Notes from 2022 Annual SMARA Inspection Conducted on 9-20-2022

by Robert Salisbury, Senior Planner James Baker, CEG#1021, County Geologist David Seymour, CEG#1574, County Geologist Steve Beams, Senior Construction Inspector

Lehigh Quarry is a vested hard rock quarry which has been in operation since approximately 1903. The operation primarily harvests limestone for the production of cement but has also produced greenstone aggregate in the past. Over time the quarrying operation has expanded, and now encompasses 546 acres of disturbed area. The site also includes a cement plant operating under a Use Permit and located outside of the Reclamation Plan area. The current Reclamation Plan was approved in 2012 as an amendment to the 1985 Reclamation Plan.

PHOTO #18 – Treatment System near former Pond 4A

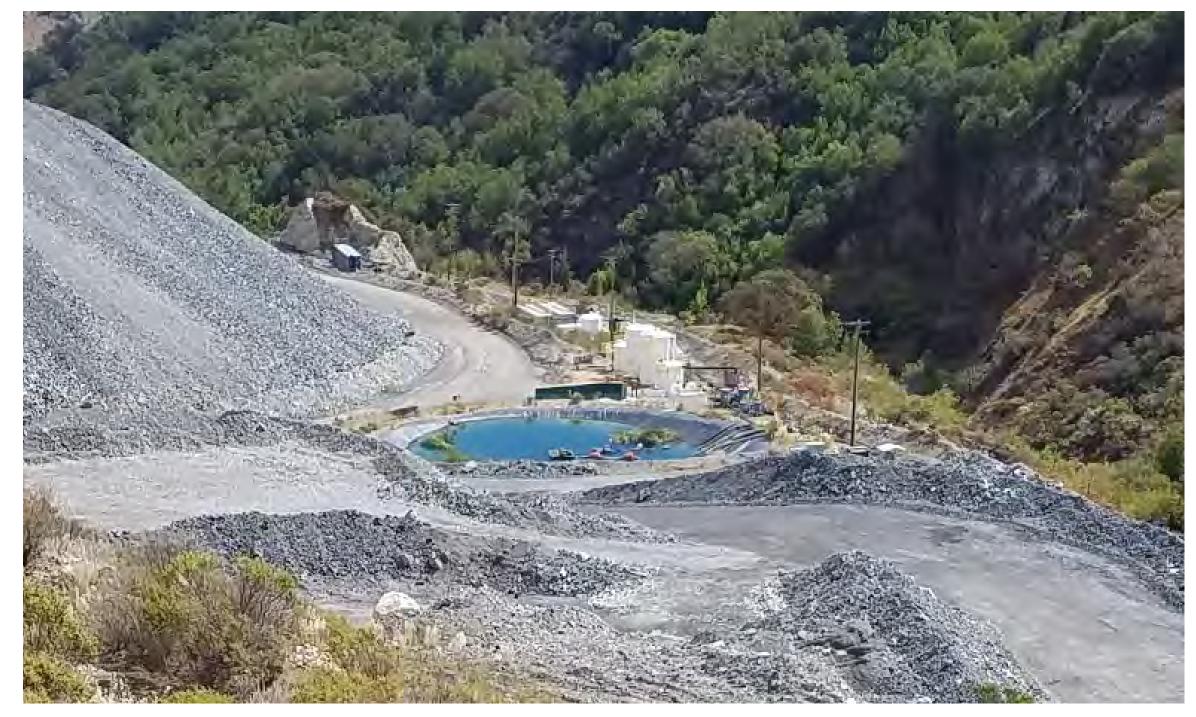
Adjacent to former Pond 4A is water treatment and filtration equipment used to remove selenium from quarry water prior to discharge into Permanente Creek. [See **PHOTOS #17** and **#18**.] Associated tanks are located adjacent to Pond 1250. [See **PHOTO #19**.]

Adjacent to former Pond 4A is water treatment and filtration equipment used to remove selenium from quarry water prior to discharge into Permanente Creek.

Photo #28A - recent fill pad south of Rock Plant

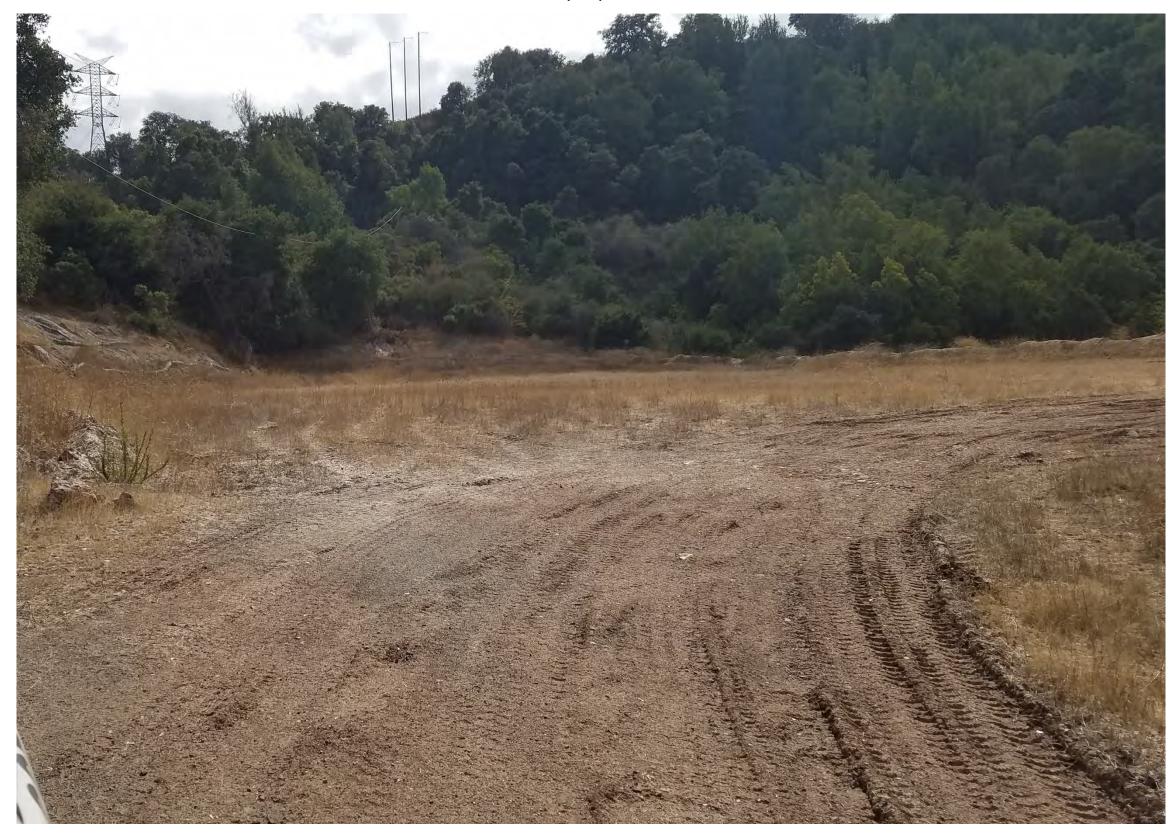
During the annual inspection in 2021, County inspectors observed an area in which recent grading had created a level pad adjacent to the modified utility road south of the Rock Plant. The fill slopes were covered with jute netting which have since been hydroseeded. [See **Photos 28A and 28B**.] In addition, at that time, County inspectors saw a localized area of shallow slumping of slopes on the northern side of fill placed in 2017 on top of the EMSA. Subsequent grading can be seen in Google Earth air-photos taken in 2020 and 2021. [See **Photos 29 A, B and C**.] Although County inspectors did not visit this area in 2022, a Google Earth air-photo taken this year (unspecified date) shows that vegetation has reestablished in that area. [See **Photo 29 D**.]

- County inspectors suggested that the operator monitor the topsoil stockpiles and replace erosion control measures as needed to prevent loss of material through erosion. (See Map Location 2.)
- 2) Area of recent grading needs to be hydroseeded in order to minimize the potential for erosion during approaching rainy season. (See area between Map Locations 6 and 12.)
- Recently formed ground cracks need to be monitored by the quarry operator to detect any increases in openings and evaluate the significance of any such changes. (See areas east of the Yeager Yard Landslide and the road to the main pit observation deck.)
